# TEXAS TURNPIKE AUTHORITY

## CONTRACT No. DNT-260

# MECHANICAL, ELECTRICAL AND PLUMBING PLANS

# ADDISON AIRPORT TUNNEL

1 PLUMBING & FIRE PROTECTION PLAN  
SCALE: 1" = 50'

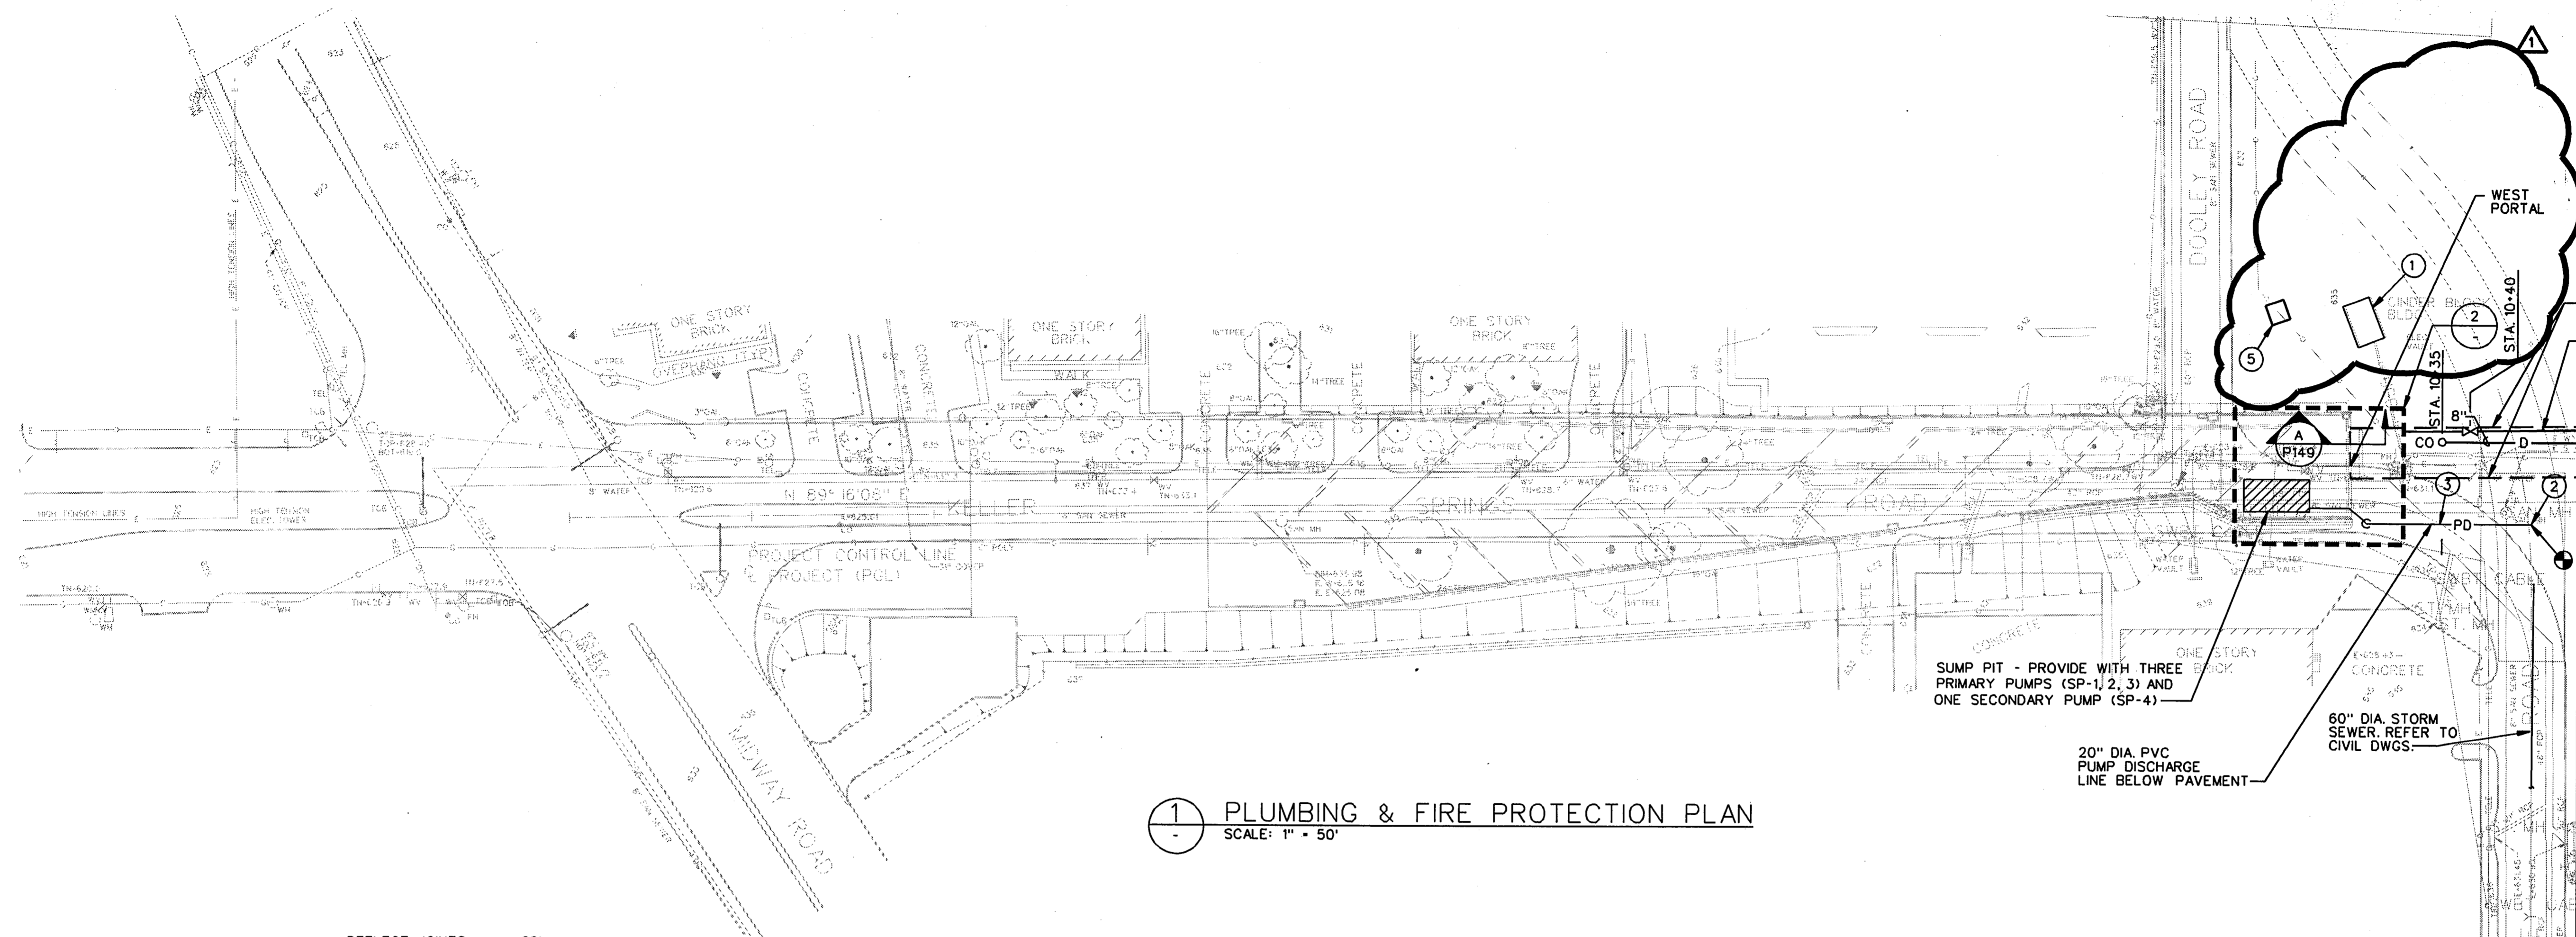
REFER TO RFI # 919  
TUNNEL MAIN 8" UNDERDRAIN PERFORATIONS

1 PLUMBING & FIRE PROTECTION PLAN  
SCALE: 1" = 50'

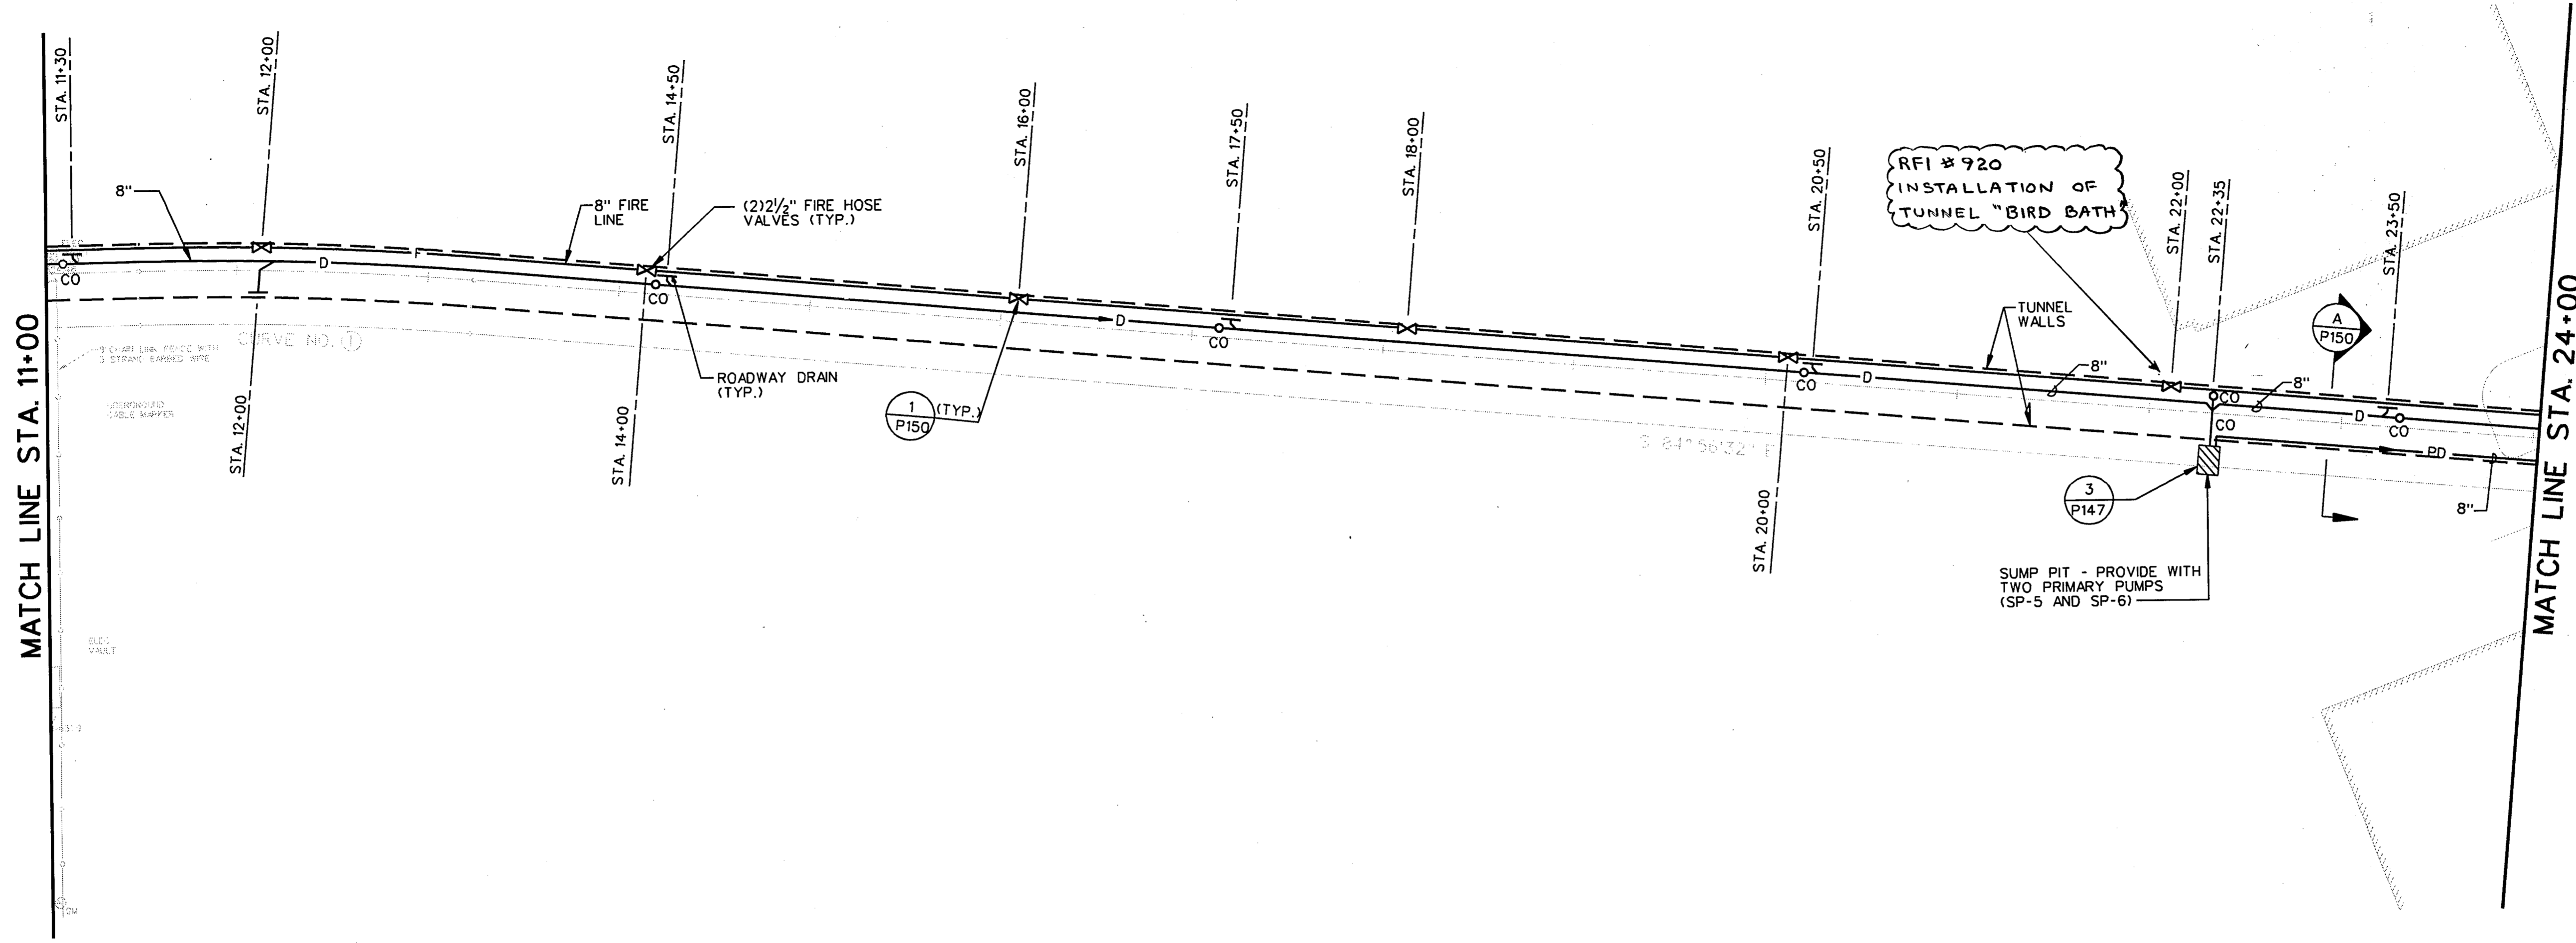
REVISION PER RFI # 920

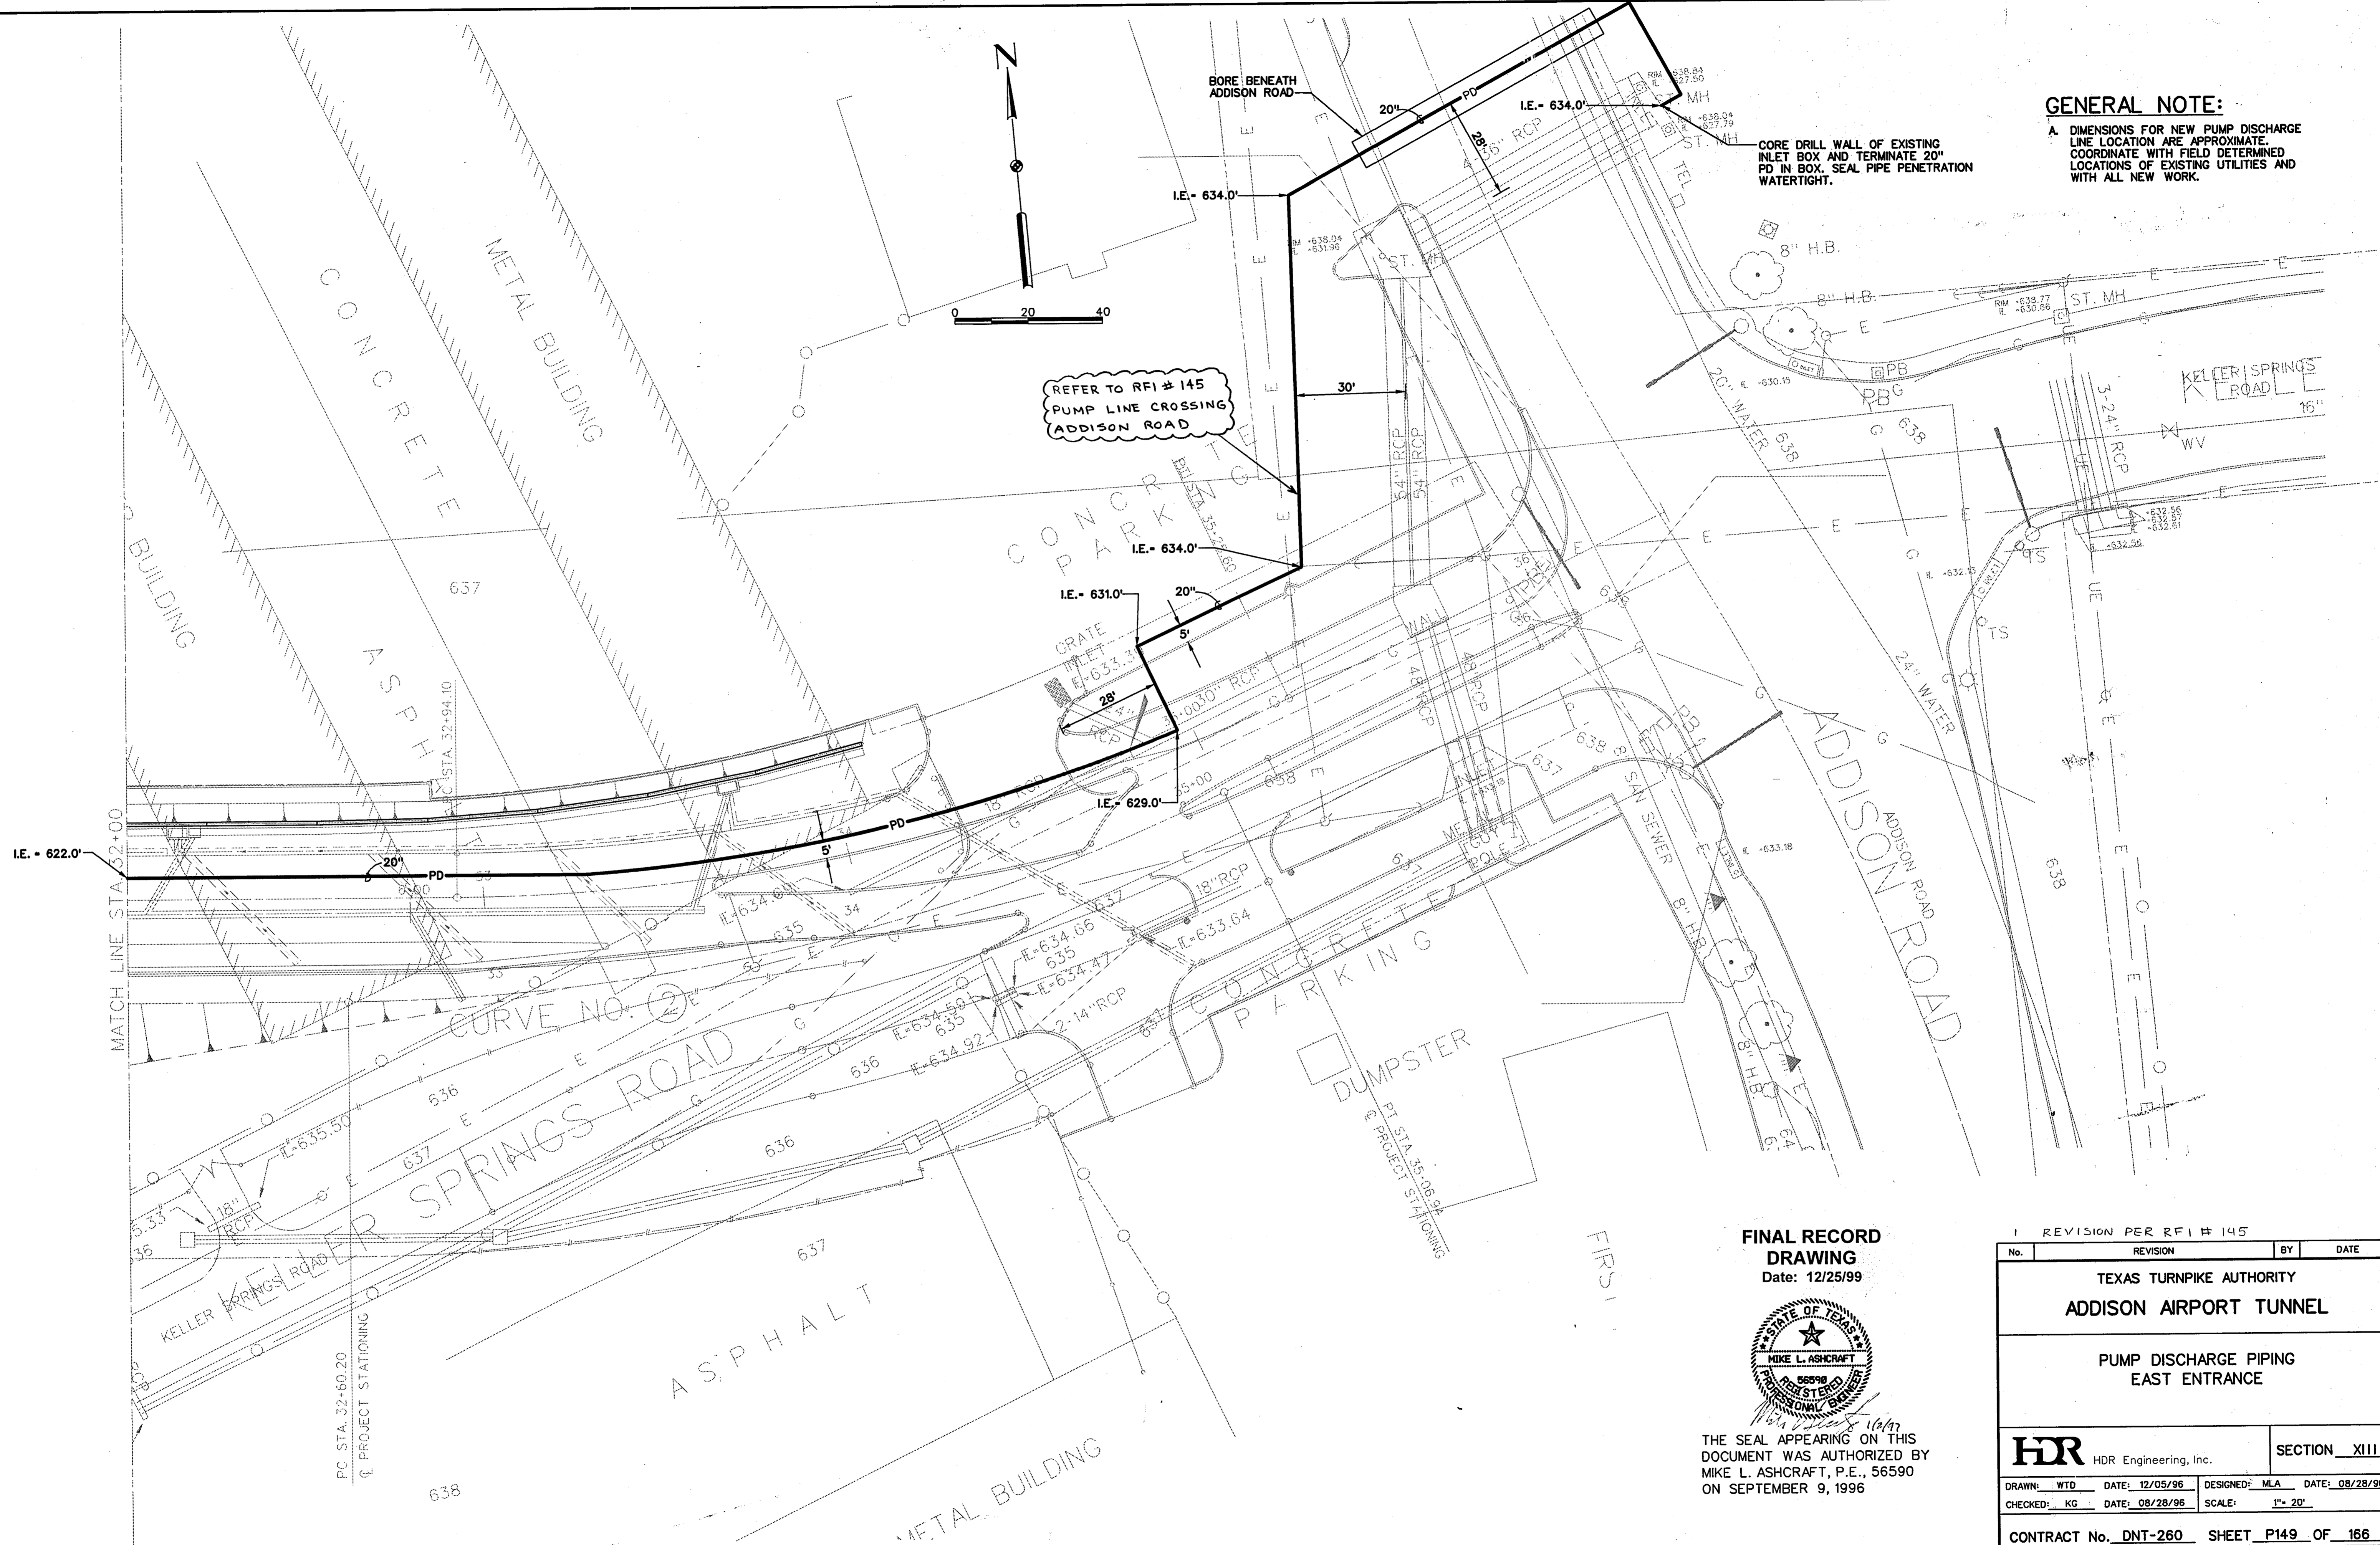
1 REVISION PER RFI # 145			
No.	REVISION	BY	DATE
TEXAS TURNPIKE AUTHORITY ADDISON AIRPORT TUNNEL			
PUMP DISCHARGE PIPING EAST ENTRANCE			
<b>HDR</b> HDR Engineering, Inc.			SECTION <u>XIII</u>
DRAWN: WTD	DATE: 12/05/96	DESIGNED: MLA	DATE: 08/28/96
CHECKED: KG	DATE: 08/28/96	SCALE:	1" = 20'
CONTRACT No. <u>DNT-260</u> SHEET <u>P149</u> OF <u>166</u>
